Re. Detached garage at 672 Beckham St.

Bedroom addition 16x12  
672 - Beckham  
Napoleon

RESIDENTIAL PLAN CORRECTION SHEET

ADDENDUM TO PERMIT NO. \_\_\_\_\_  
Owner \_\_\_\_\_  
Contractor Felipe Coronado (Wauseon)  
Location 672 Beckham

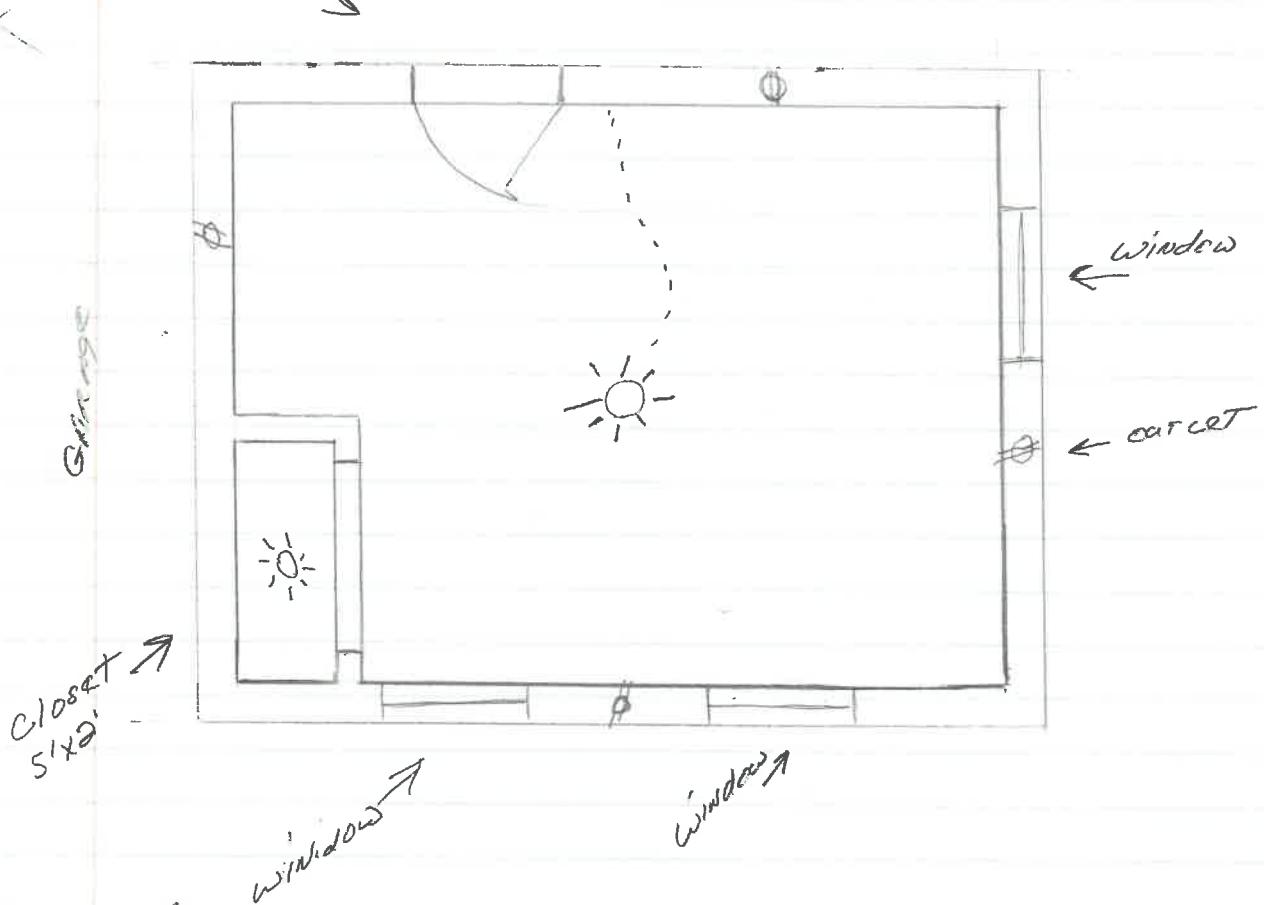
Additional corrections: Provide min. 5 sq. ft. clear opening window at least 22" High + 20" wide.
